Addendum to the Loomis Creek Eco-hydrology Phase 1 Study (2025): Review of the Updated 2026 Annual Operating Plan

May 25, 2026

Prepared for: Canadian Parks and Wilderness Society

Prepared by: Matt Coombs, M.Sc., P.Biol., Fintegrate Fisheries & Watershed Consulting Ltd

Figure 1. Digitized overlay of model-predicted annual hydrographs for Loomis Creek based on forest cover change associated with the original and updated AOPs; reproduced from Figure 13 (Chernos et al. 2024) and Figure 18 (MacDonald et al. 2026).

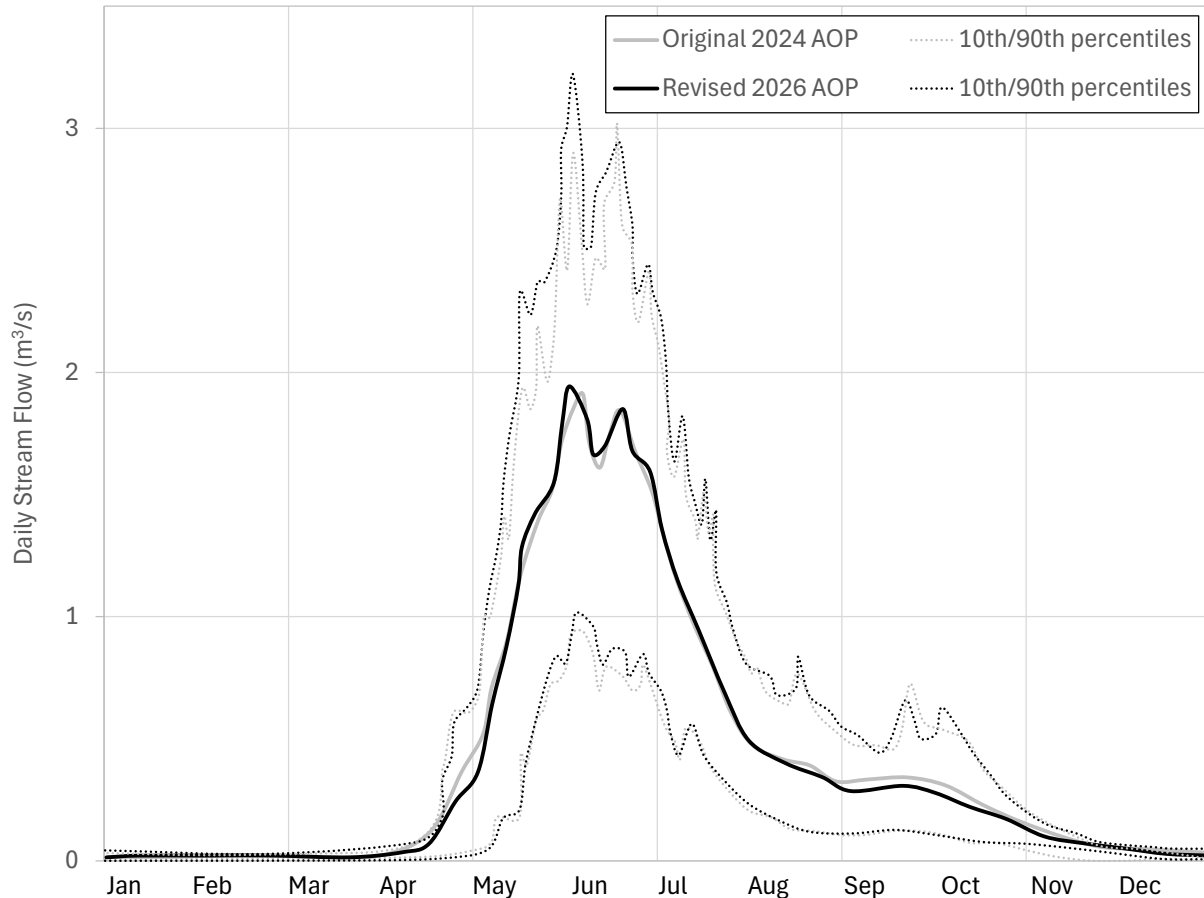
The predicted annual hydrographs based on model outputs using the original and updated AOP are similar. This can be seen when Figure 13 (Chernos et al. 2024) and Figure 18 (MacDonald et al. 2026) are digitized and data are replotted on a common x-axis (**Figure 1**).

Hydrologic alteration resulting from the planned logging is not as apparent when changes are only considered on an annual basis (i.e., increase in annual flows, increase in 2- and 20-year peak flows, and timing of freshet). Broader seasonal increases in spring daily flows have not been considered, despite this period being the most significant period in terms of altering channel morphology and bull trout critical habitat. Instead, only the low flow period has been examined by MacHydro (i.e., mean August-September flow). While this period is critical in terms of minimum flows necessary for bull trout migration and spawning, it is not relevant in terms of high flows disturbing critical habitat.

Figure 2. Reproduction of a portion of Figure 20 from MacHydro et al. (2026) showing the percent change in daily average stream flow for current conditions (fully forested) and proposed harvest. The dark line is the average percent change for each day and shading shows the 10th and 90th percentile.

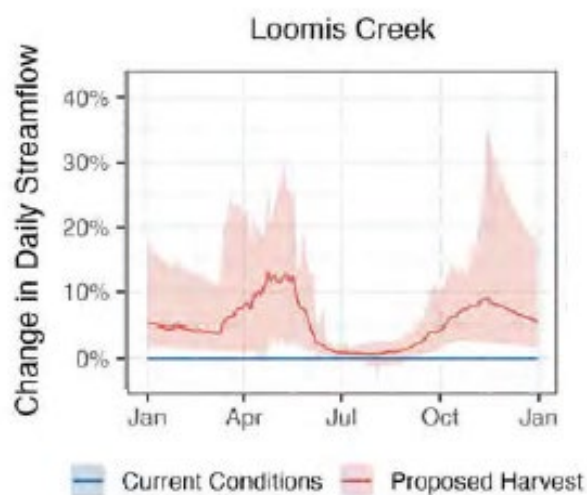
As noted above, critical habitat could be degraded by higher flows resulting from logging if flows remain elevated throughout the spring freshet. Figure 20 in MacHydro et al. (2026) is reproduced below (**Figure 2**) and shows the model-predicted percent change in daily stream flows over the year for the updated AOP forest harvest scenario. It shows a 2.5-month long period in the spring of daily flows being on average 10-13% higher than if forest harvest did not occur. Even though it also shows a significant but smaller period in the fall

when daily flows are 6-8% higher than baseline, flows at this time of year are much lower and are rarely high enough to change channel morphology. The model-predicted percent change in daily stream flows also shows the lower 10th percentile remains above zero throughout most of the year (**Figure 2**), indicating an overall increase in flows is broadly predicted from the planned forest harvest in the updated AOP. The 90th percentile of model-predicted percent change in daily stream flows also peaks as high as 30% in the spring, indicating large increases in daily flows during the freshet are possible even for the updated AOP. Sustained increases in daily flows of 10-13% over 2.5 months or shorter-term increases of up to 30% could significantly alter bull trout habitat quality through a variety of flow driven channel disturbances. While the MacHydro assessment of the original AOP (Chernos et al. 2024) did not present the same percent increases in daily flows, these would be greater than shown below (**Figure 2**).

Figure 3. Parts of planned road and cut blocks within respective 100 m and 60 m buffers on large permanent streams.

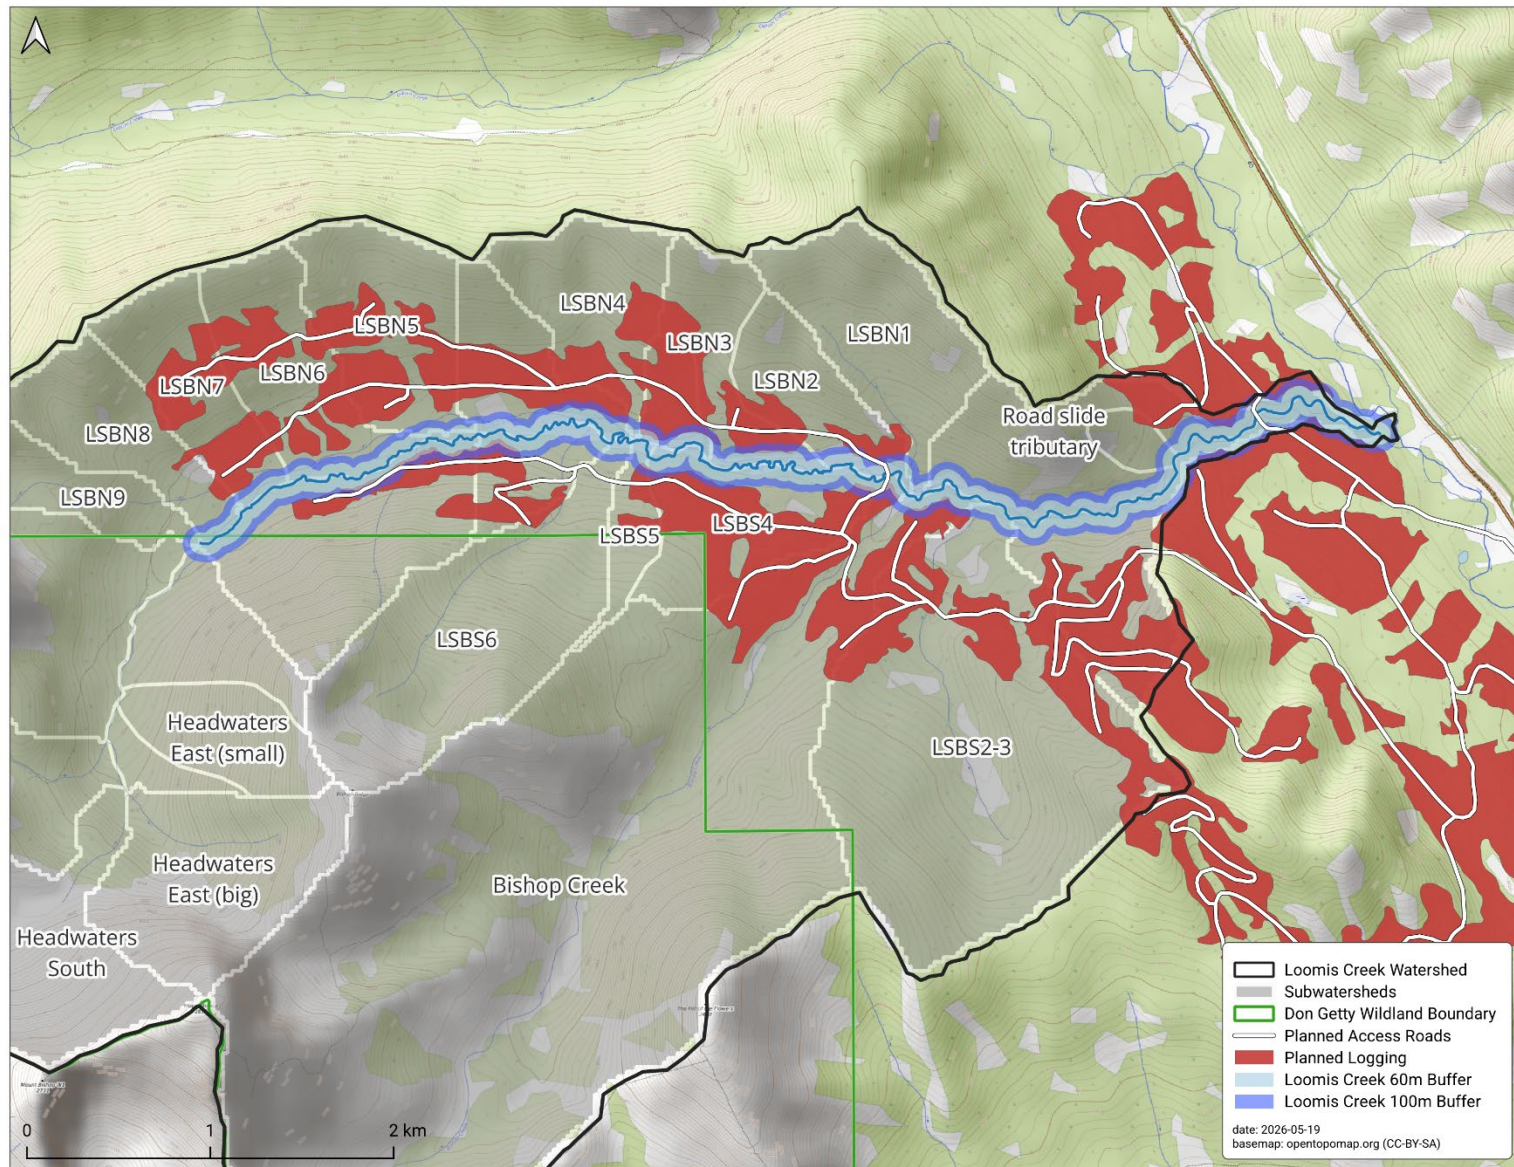
Layout issues persist based on the riparian buffers prescribed in the OGRs. According to Table 4 of Section 2.17 (Aquatic and Riparian Area Protection) of the OGRs (Government of Alberta 2024), large permanent streams should have no removal of timber within 60 m. However, at two locations along the south side of Loomis Creek, portions of the cut blocks still overlap with this prescribed 60 m buffer in the updated AOP (**Figure 3**).

- One area where the cut blocks are within this 60 m prescribed buffer is near the Bishop-Loomis creek confluence, extending approximately 300 m upstream and 250 m downstream of Bishop Creek.
- The other area is near the upstream extent of the AOP on the South side of Loomis Creek, from west of the LSBS6 confluence to near the upstream extend of the AOP and the Don Getty Wildland boundary.

Figure 4. Planned logging overlapping or within 30 m of areas mapped as wetlands.

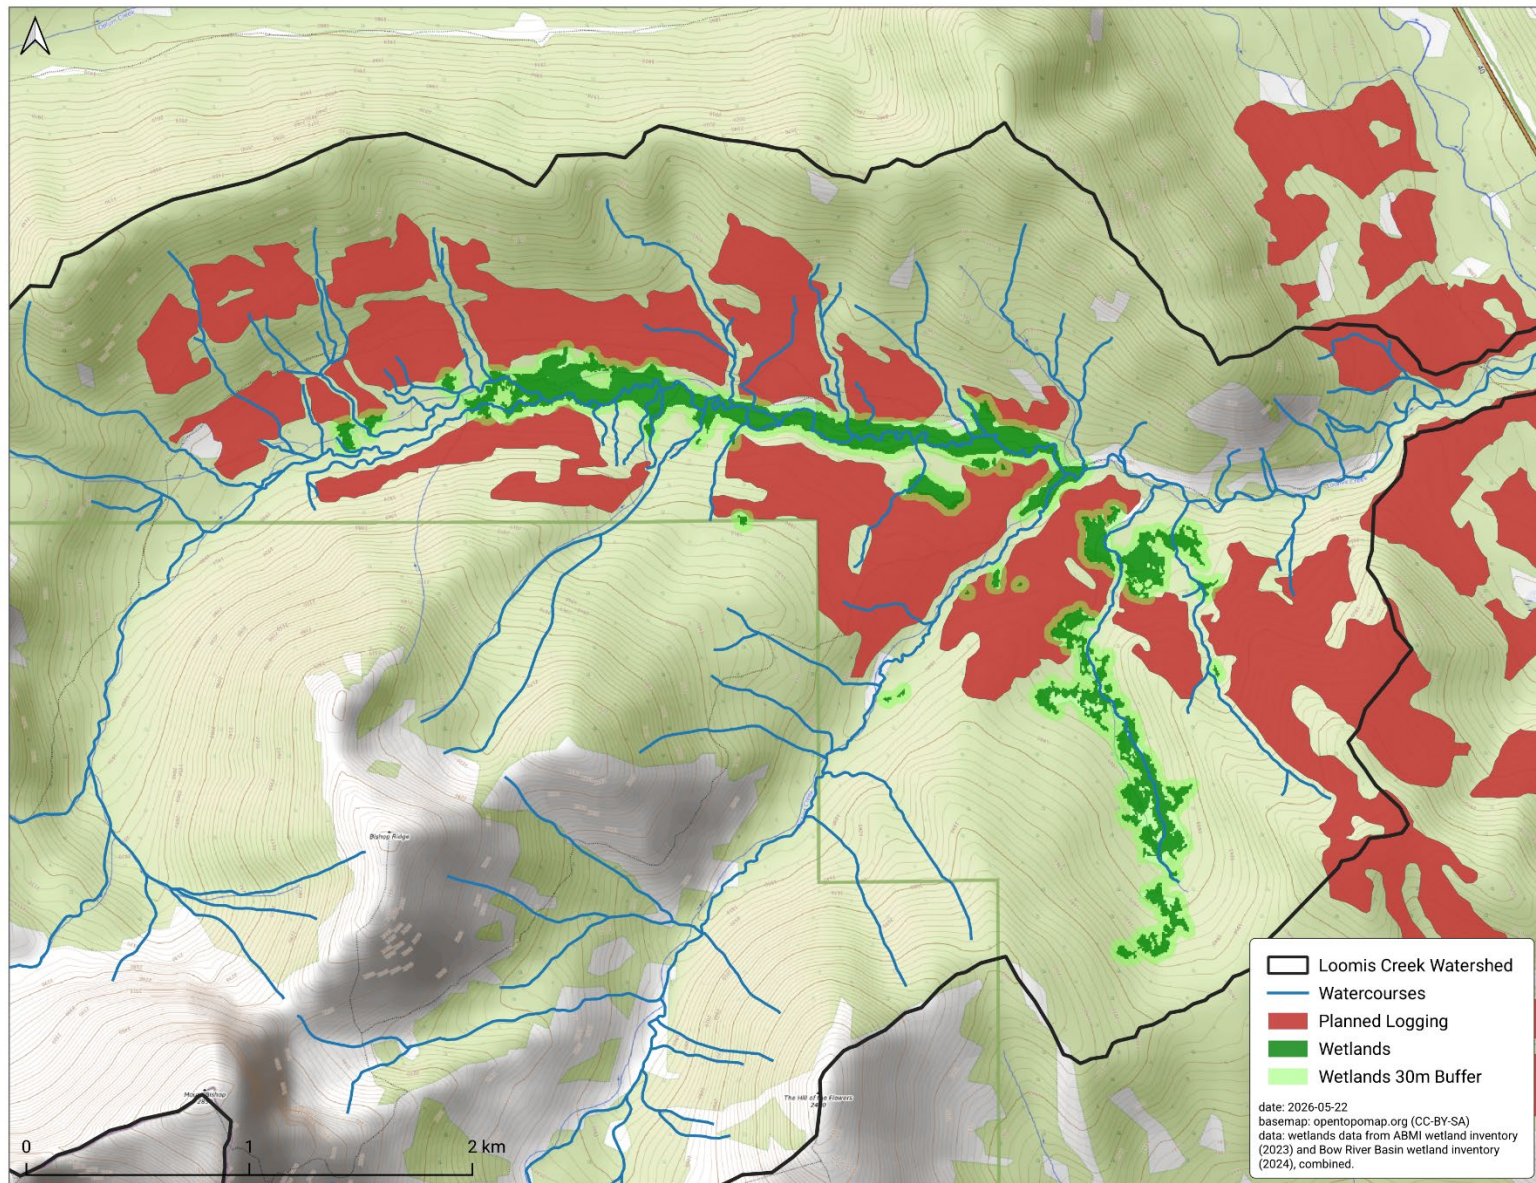
The SARA bull trout recovery strategy (Fisheries and Oceans Canada 2020) applies a 30 m riparian buffer to all mapped and unmapped water features that are hydrologically connected to mapped critical habitat and support the features, functions, and attributes that bull trout rely on for survival and reproduction. Wetlands directly support bull trout critical habitat through floodwater and groundwater storage and gradual release of water and nutrients that support the aquatic food chain. However, in some locations in the AOP, the edge of wetland areas where there is shallow groundwater and saturated soil that drains to mapped critical habitat still has not been buffered by 30 m. Instead, the 30 m buffer has been applied just from the banks of the watercourse within the wetland and clearcuts are planned to extend to the forested edge of the wetlands.

Figure 5. Planned logging overlapping parts of the provincial Wet Area Mapping layer.

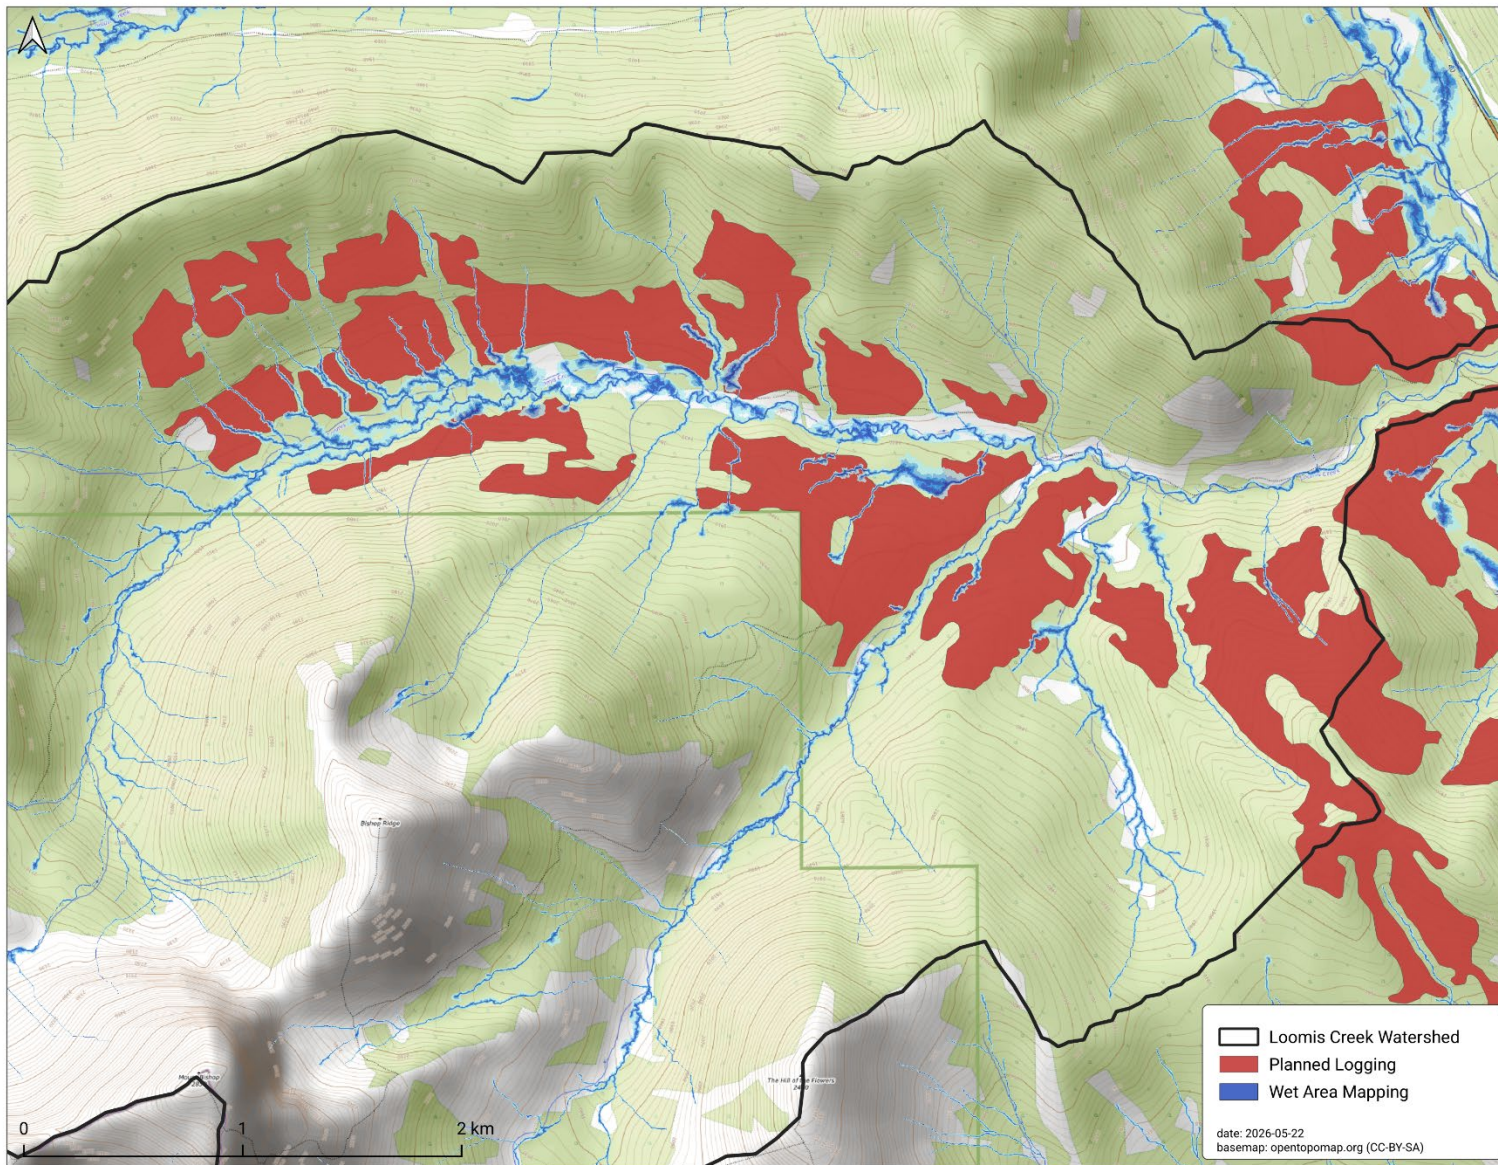
A significant number of mapped wet areas on the WAM layer overlap with the updated AOP cut blocks (**Figure 5**). Some WAM layer areas of concern that remain in the updated AOP and have not had riparian buffers placed around them are listed below (**Table 6**).
